Access Compliance Report

Public Rights-of-Way

(Pedestrian Signals)

Intersection ID: N/A	Main Street:	Cross Street: N/A	Location: N/A
ADA ID: CB99F7406B3B	Signal Type: One Push Button-Non APS	Overall Compliance: No	Severity Score: BTN 1: N/A BTN 2: N/A No BTN: N/A
Codes/Mitigation Info/Possible Solution		Field Measurements/Component Compliance

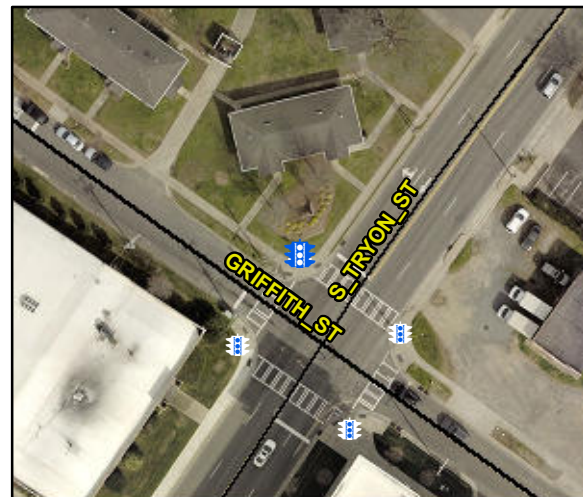
PROW/ADA: TMUTCD 4e.08, R404.3, R404.2, R406.2

Compliance	Description	Data	Compliance	Description	Data
	Button Count	Button1	N/A	Distant to Additional Button (in)	N/A
	Additional Button Present?	No		Additional Button ID	N/A
N/A	Signal Buttons Required?	N/A	N/A	Additional Ped Posts Required	N/A
	How Many Ped Street Xings?	2		Located In An Island/Median?	No
N/A	B 1 Sign Present?	Yes	N/A	B 2 Sign Present?	N/A
Yes	B 1 Sign Purpose?	Yes	N/A	B 2 Sign Purpose?	N/A
Yes	B 1 Sign Lettering & Contrast?	Yes	N/A	B 2 Sign Lettering & Contrast?	N/A
Yes	B 1 Parallel To XWalk?	Yes	N/A	B 2 Parallel To XWalk?	N/A
No	B 1 PAR to Button?	No	N/A	B 2 PAR to Button?	N/A
No	B 1 PAR to XWalk?	No	N/A	B 2 PAR to XWalk?	N/A
Yes	B 1 Clear Floor Space?	Yes	N/A	B 2 Clear Floor Space?	N/A
N/A	B 1 FWD Approach?	Yes	N/A	B 2 FWD Approach?	N/A
N/A	B 1 FWD Approach Constrained?	No	N/A	B 2 FWD Approach Constrained?	N/A
No	B 1 FWD Approach Reach (in)	7.0	N/A	B 2 FWD Approach Reach (in)	N/A

N/A	B 1 FWD Approach Width (in)	N/A	N/A	B 2 FWD Approach Width (in)	N/A
N/A	B 1 FWD Approach Obstruction?	Yes	N/A	B 2 FWD Approach Obstruction?	N/A
N/A	B 1 FWD Approach Obstruction Dist (in)	0.0	N/A	B 2 FWD Approach ObstructionDist (in)	N/A
N/A	B 1 PARA Approach?	Yes	N/A	B 2 PARA Approach?	N/A
N/A	B 1 PARA Approach Constrained?	No	N/A	B 2 PARA Approach Constrained?	N/A
Yes	B 1 PARA Approach Reach (in)	5.0	N/A	B 2 PARA Approach Reach (in)	N/A
N/A	B 1 PARA Approach Width (in)	N/A	N/A	B 2 PARA Approach Width (in)	N/A
N/A	B 1 PARA Approach Obstruction?	Yes	N/A	B 2 PARA Approach Obstruction?	N/A
N/A	B 1 PARA Approach Obstruction Dist (in)	0.0	N/A	B 2 PARA Approach ObstructionDist (in)	N/A
No	B 1 Clear Floor Space Slope (%)	2.2	N/A	B 2 Clear Floor Space Slope (%)	N/A
Yes	B 1 Clear Floor Space XSlope (%)	0.0	N/A	B 2 Clear Floor Space XSlope (%)	N/A
N/A	B 1 PAR Slope (%)	1.9	N/A	B 2 PAR Slope (%)	N/A
Yes	B 1 Height (in)	40.0	N/A	B 2 Height (in)	N/A

Yes	B 1 Clear Xing Direction?	ClearlyMarked	N/A	B 2 Clear Xing Direction?	N/A
	B 1 Crossing Direction	To SE		B 2 Crossing Direction	N/A
Yes	B 1 DistanceTo XWalk (in)	0.0	N/A	B 2 DistanceTo XWalk (in)	N/A
No	B 1 DistanceTo Curb (in)	108.0	N/A	B 2 DistanceTo Curb (in)	N/A
Yes	B 1 Diameter (in)	2.0	N/A	B 2 Diameter (in)	N/A

Possible Solutions: Replace Signal Push Button With APS Button on New Post. Remove & Relocate Sign.
